V2500-A5 SERIES NACELLE SERVICE BULLETIN

This document transmits Revision 2 to Service Bulletin NV2500-71-0206

Reason for change To add new Mounting Bracket and Sealing Block to work instructions and to kit list.

NACELLE - POWERPLANT - COWL, AIR INTAKE - REWORK TO ACCOMMODATE LONGER P2T2 PROBE

Modification of P2/T2 Support Structure Figure 1 Sheet 1 of 4

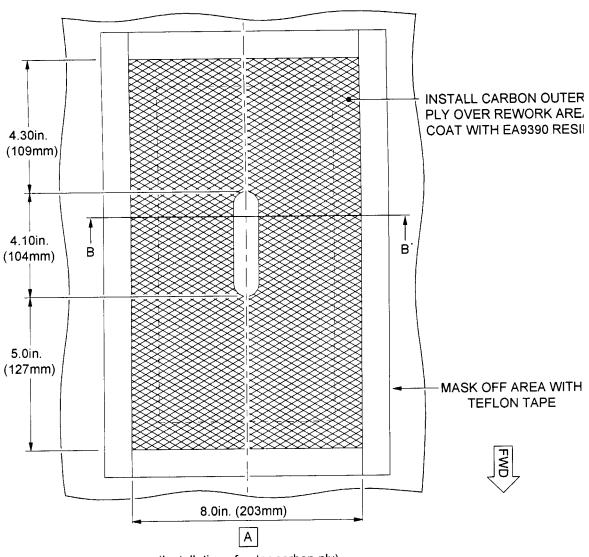
- (1) Clean the area with a clean lint-free cloth (CoMat O2-099) made moist with solvent (CoMat O1-076) or (CoMat O1-457). Wipe the area dry before the solvent evaporates.
- (2) Draw a pencil line around the area of steel mesh to be removed as shown. Refer to Figure 1 Sheet 1.
- (3) Cut the stainless steel mesh with a sharp knife and carefully remove. Make sure you do not damage the underlying loose weave carbon fibre layer.

- (5) Obey the above warning and mix a quantity of EA934NA Resin (CoMat 08-021) in accordance with the manufacturers instructions.
- (6) Mask off the area for resin injection with Teflon tape (CoMat O2-007) as shown. Refer to Figure 1 Sheet 1.

Modification of P2/T2 Support Structure Figure 1 Sheet 2 of 4

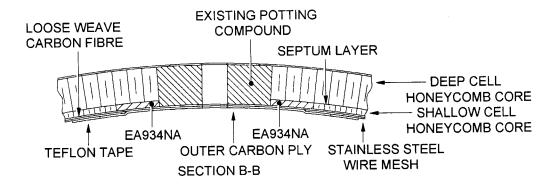
- (b) Cut one piece of dry carbon fibre material (CoMat 08-059) so that it has a 1.0in (25.4 mm) overlap around the rework area. To prevent fraying, cut the material to the finished dimensions after it has been soaked with resin. Refer to Figure 1 Sheet 2.

Modification of P2/T2 Support Structure Figure 1 Sheet 3 of 4

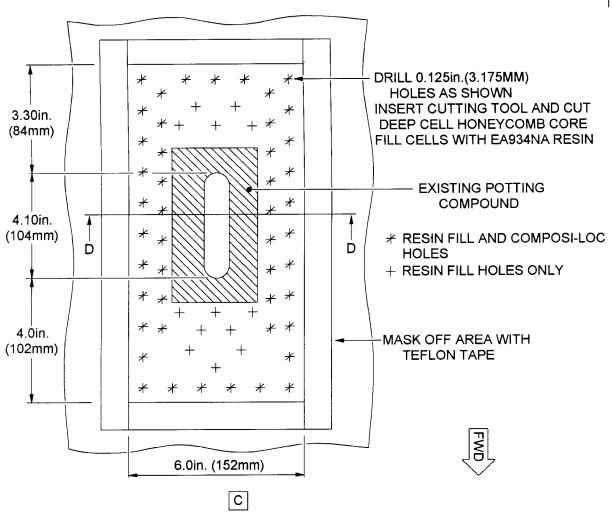
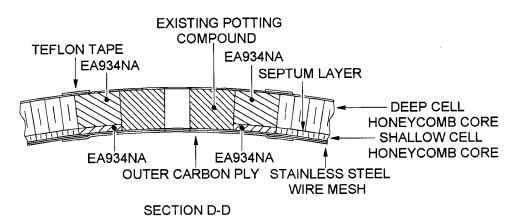
- (17) Clean the area with a clean lint-free cloth (CoMat 02-099) made moist with solvent (CoMat 01-076) or (CoMat 01-457). Wipe the area dry before the solvent evaporates.
- (18) Gain access to the other side of the P2T2 rework area. Refer to Figure 1 Sheet 3.
- (19) Use a 3/16 in (5.10 mm) drill to remove the 12 off Composi-loc fasteners that attach the 740-3090-501 Mounting Bracket and 740-3093-501 Sealing Block to the intake panel.

- (20) Clean the area with a clean lint-free cloth (CoMat 02-099) made moist with solvent (CoMat 01-076) or (CoMat 01-457). Wipe the area dry before the solvent evaporates.
- (21) Mask off the area for resin injection with Teflon tape (CoMat O2-007) as shown. Refer to Figure 1 Sheet 3.

Modification of P2/T2 Support Structure Figure 1 Sheet 4 of 4

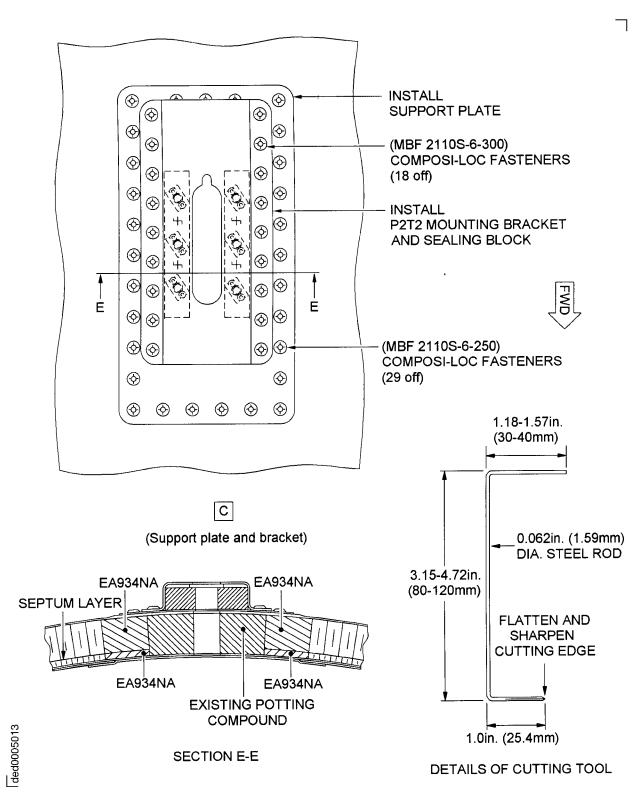
- (24) Cut away the honeycomb from below the holes as shown. Use the cutting tool shown in Figure 1 Sheet 4.
- (25) Drill out the 47 off Composi-loc holes in the backing skin to 0.205in (5,20 mm) dia. as shown.
